This Value Engineering report summarizes the results of the Value Engineering study performed by Ventry Engineering for the Kentucky Transportation Cabinet. The study was performed during the week of February 2-6, 1998.

The subject of the study was the I-75 Widening from KY 36 to KY 491 (Williamstown to Crittenden).

Crittenden - Mt. Zion / I-75
VE - 2

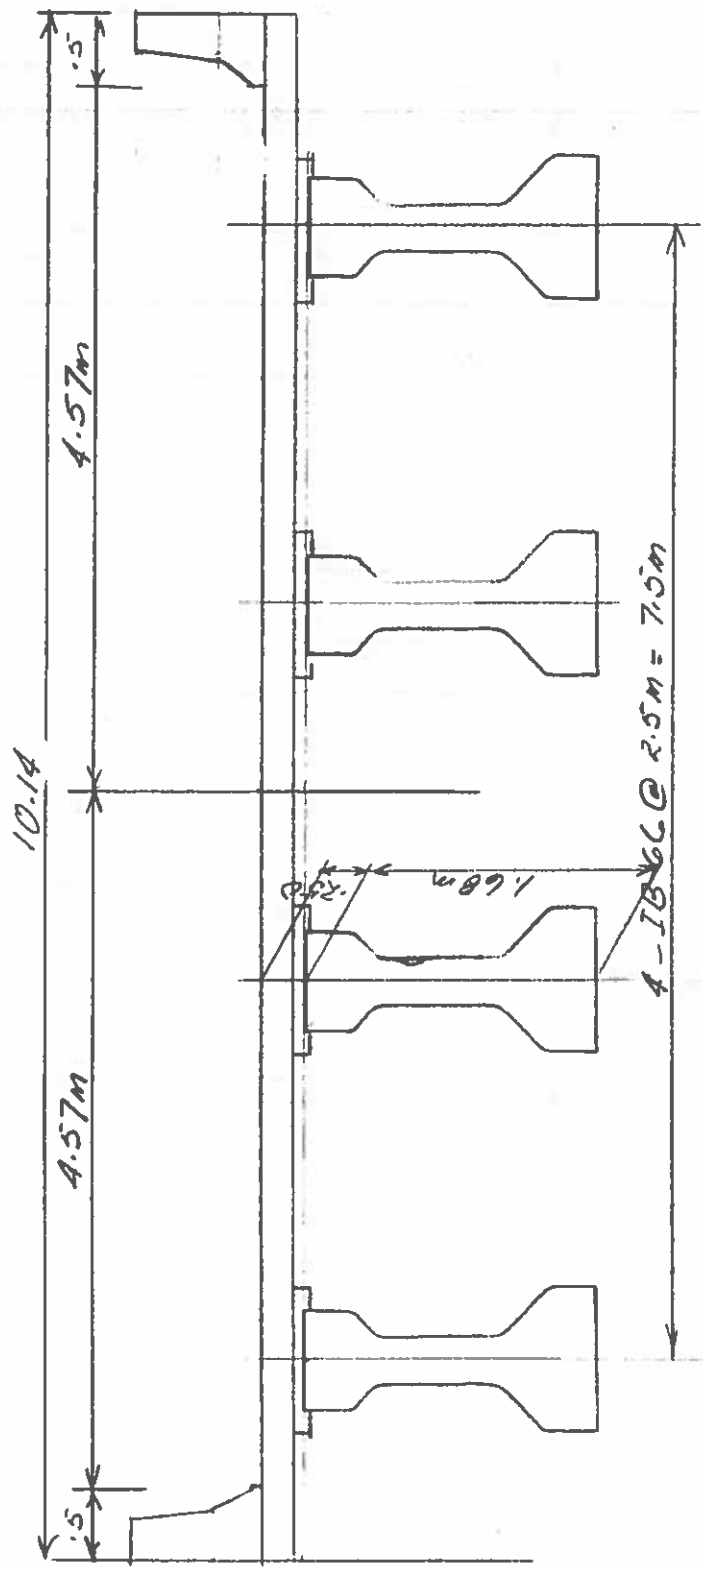
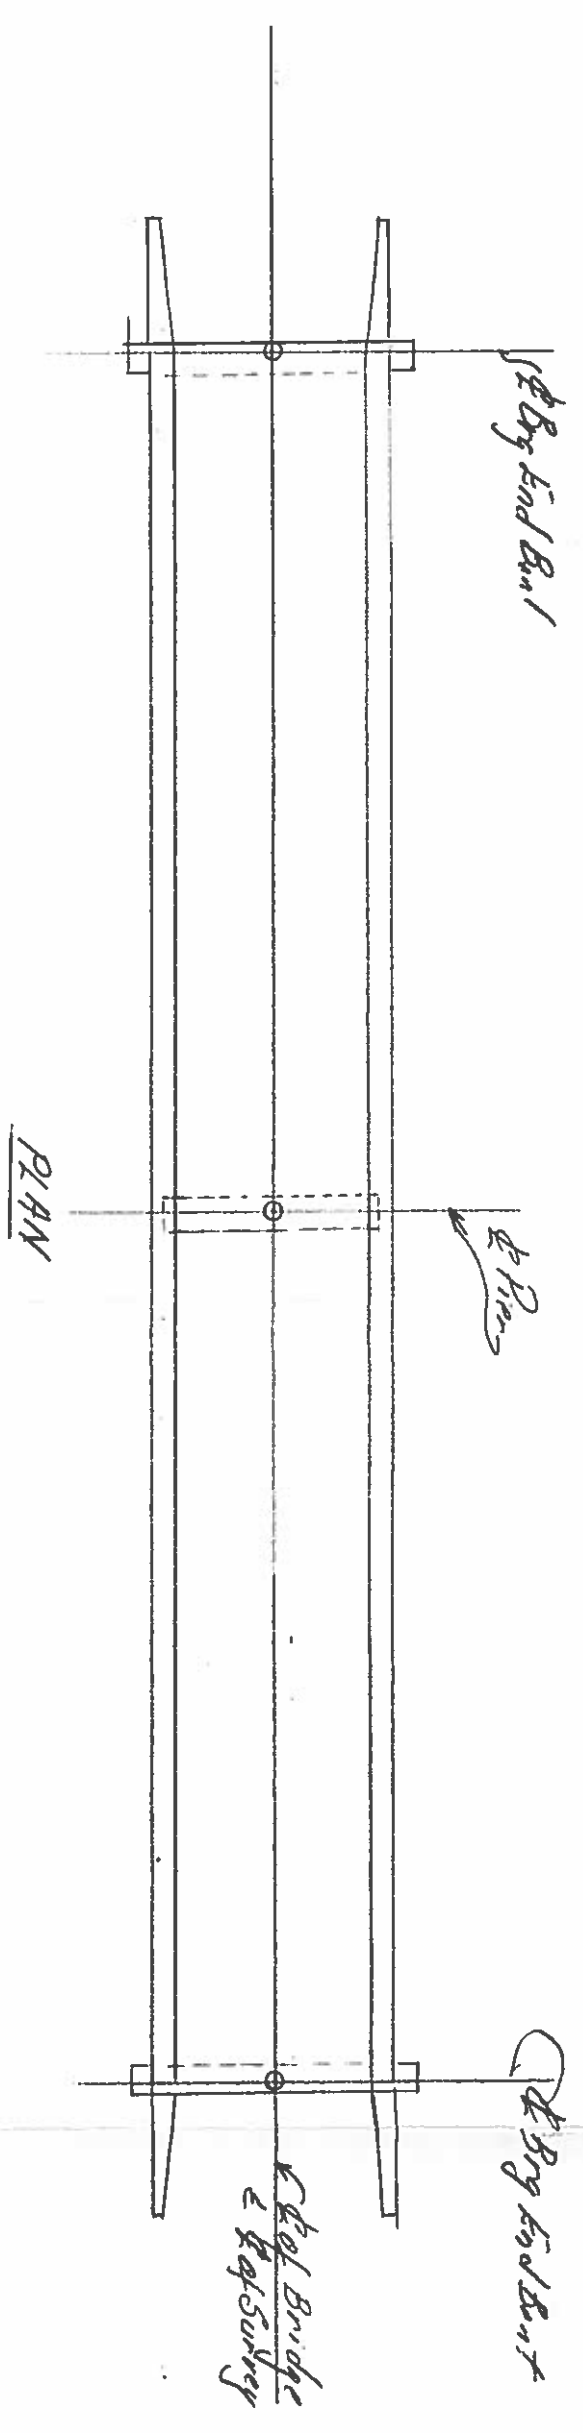
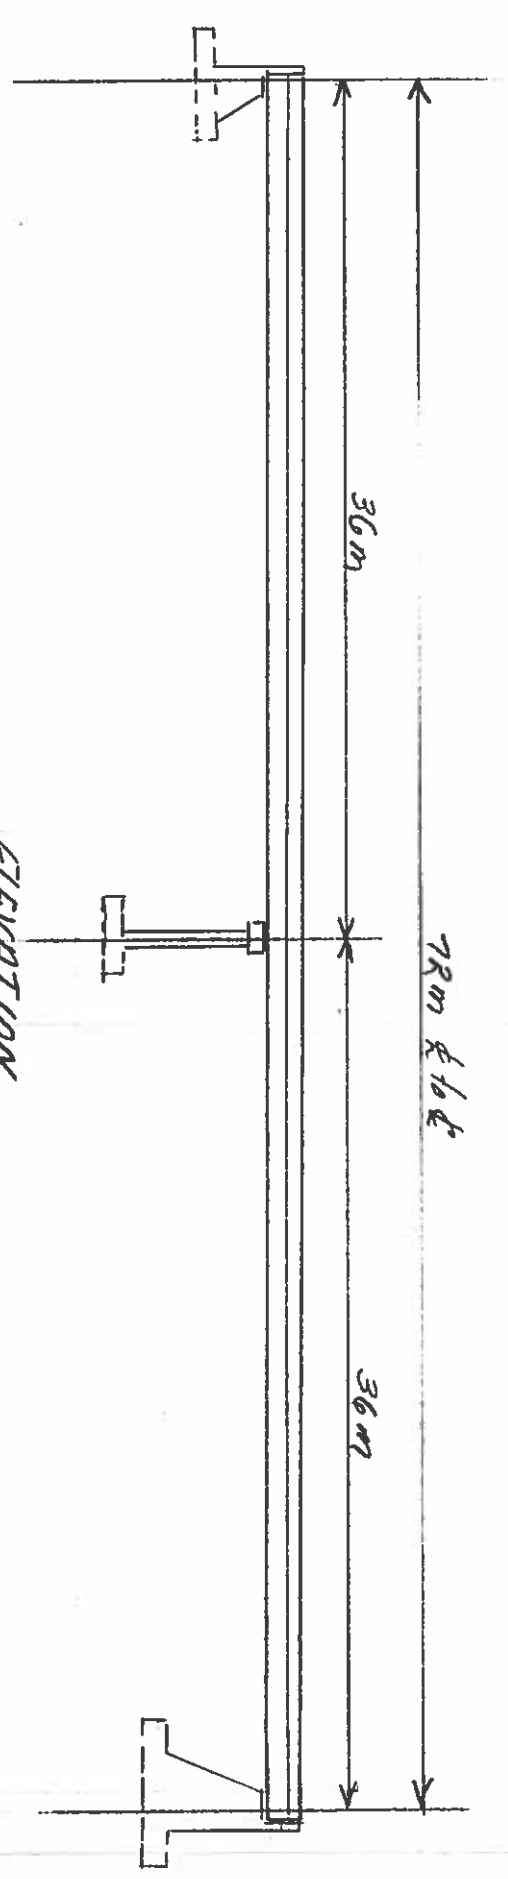
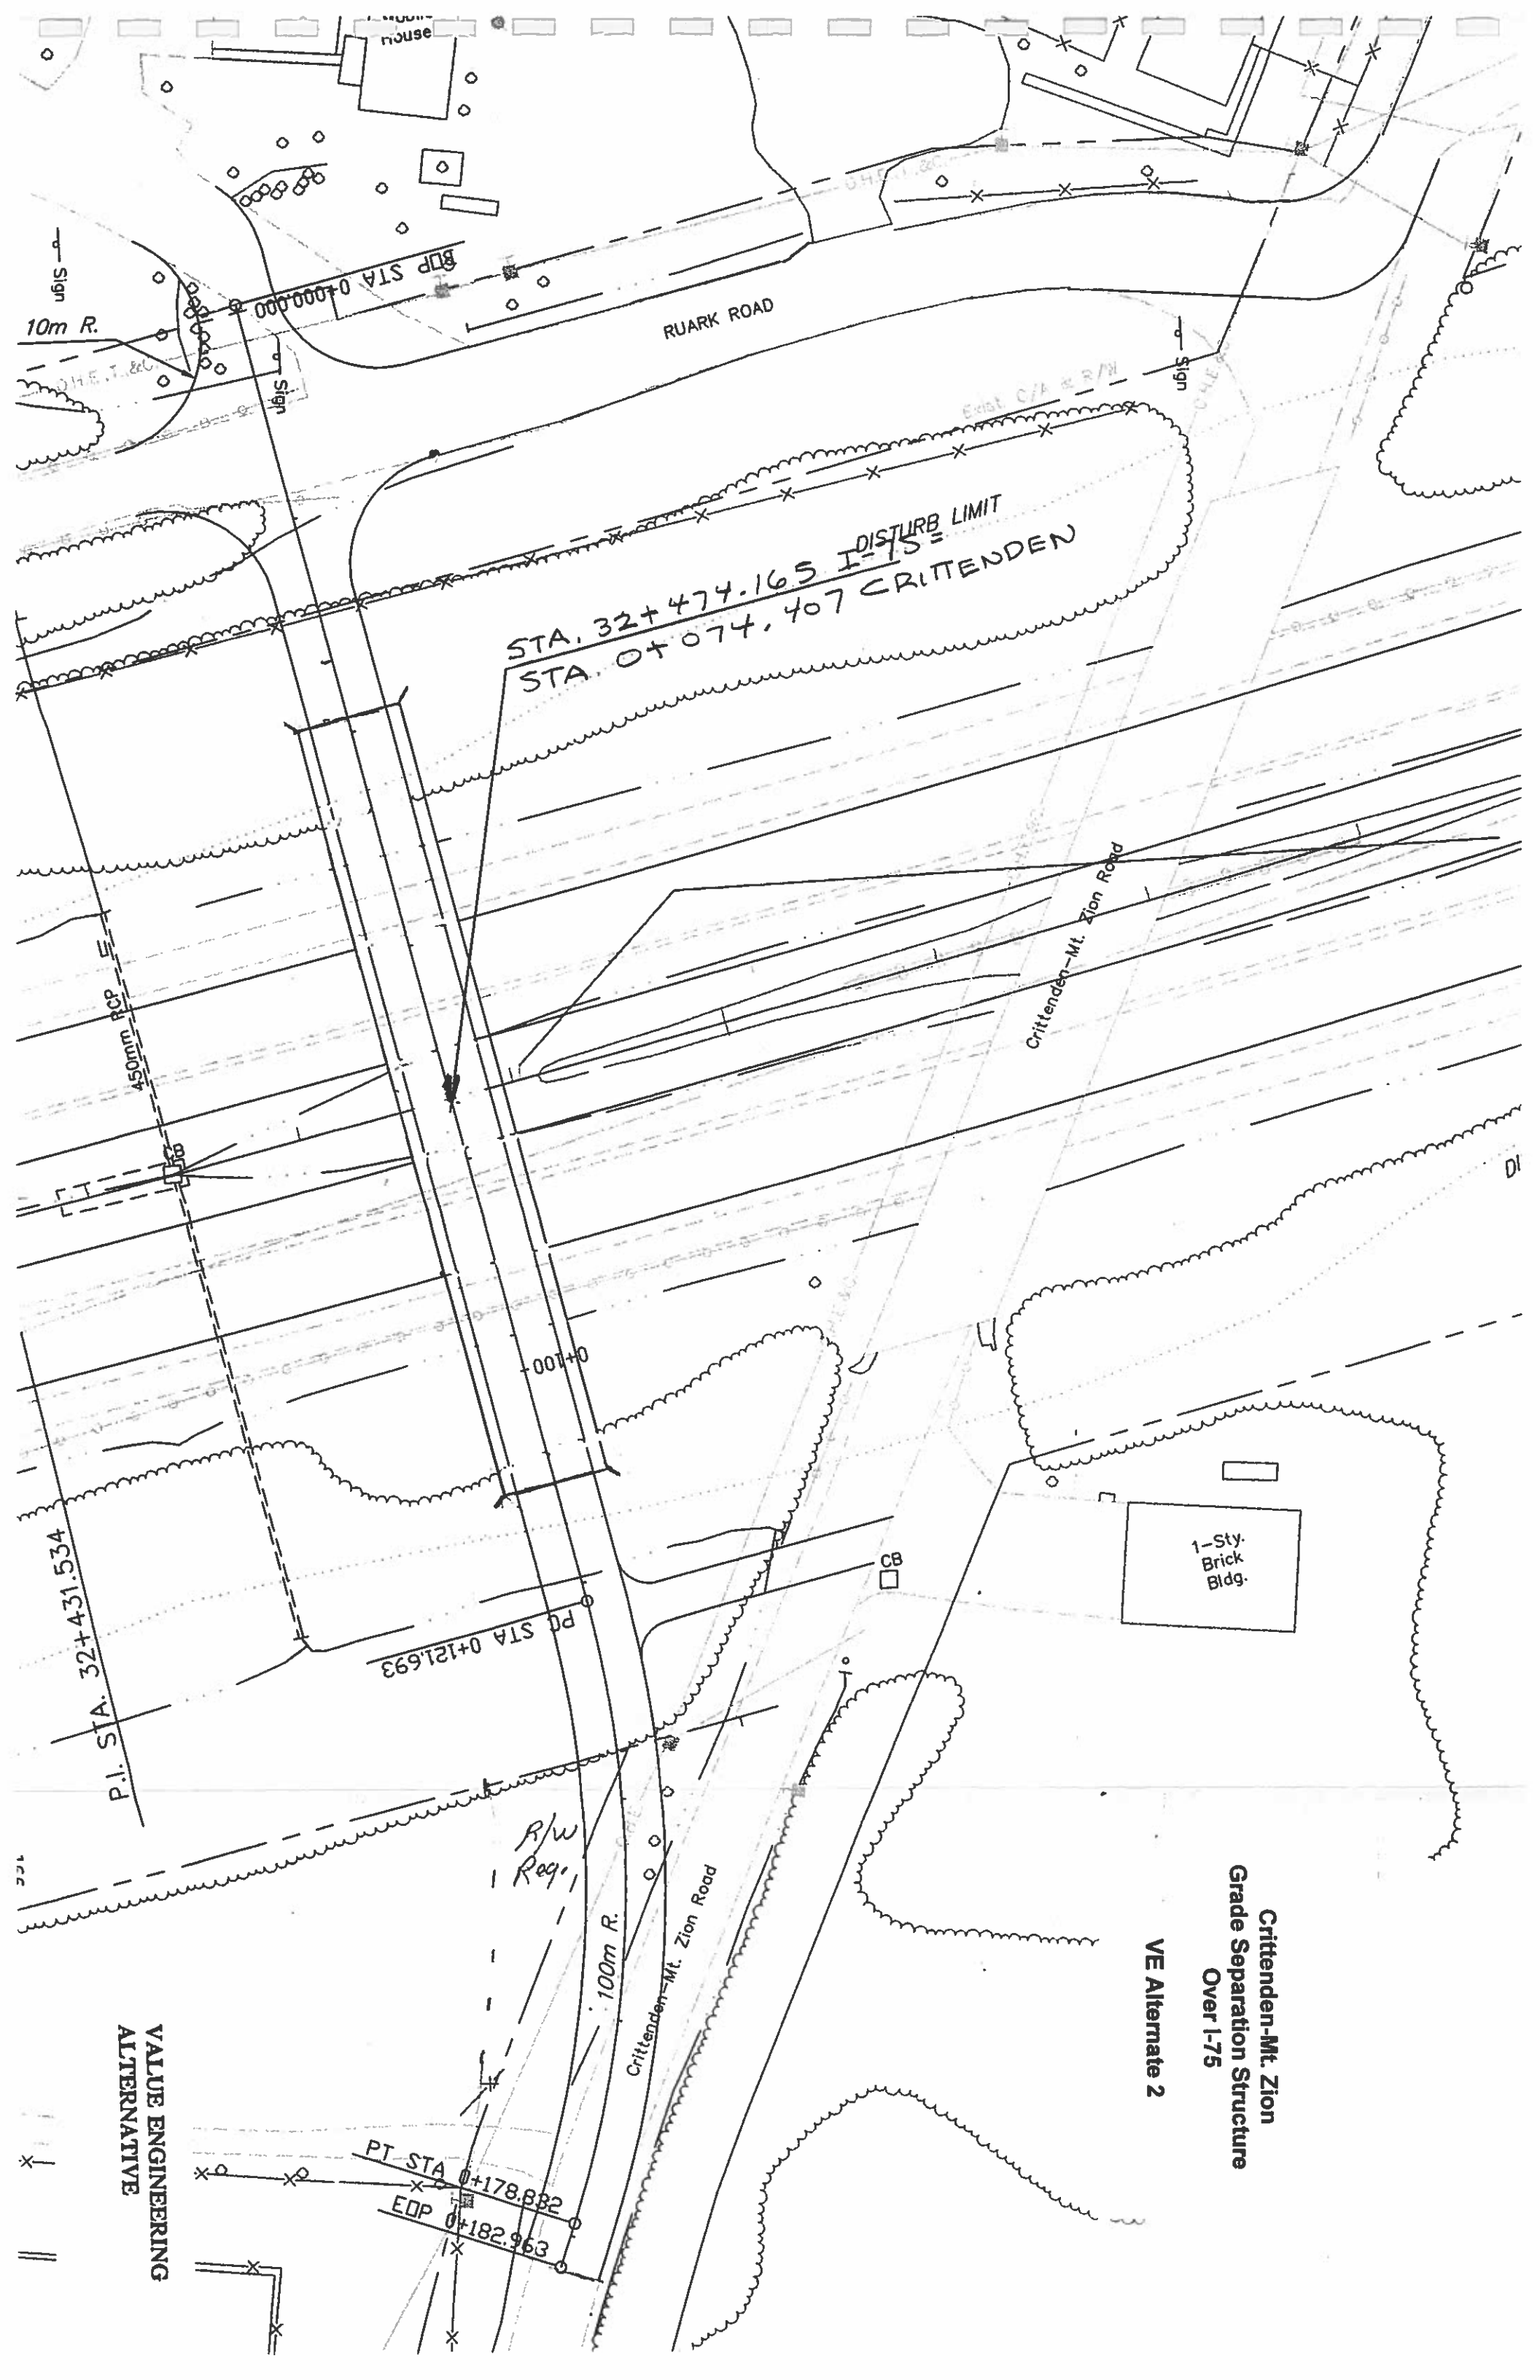
The Value Engineering Alternative No. 2 utilizes a two span bridge that spans I-75 on a 90 degree crossing. Crittenden/Mt. Zion Rd. will be realigned south of the existing crossing. The new bridge utilizes AASHTO Type V prestressed concrete beams with spans of 36 meters. This alternative utilizes the existing bridge for MOT. Therefore, construction schedule will not be affected by the schools schedule. The bridge length is minimized. The roadway realignment requires minimal right of way. The alignment improves the entrance to the high traffic generator mobile home park. The estimate includes the cost of upgrading Roark Road. This alternative saves approximately \$305,000.
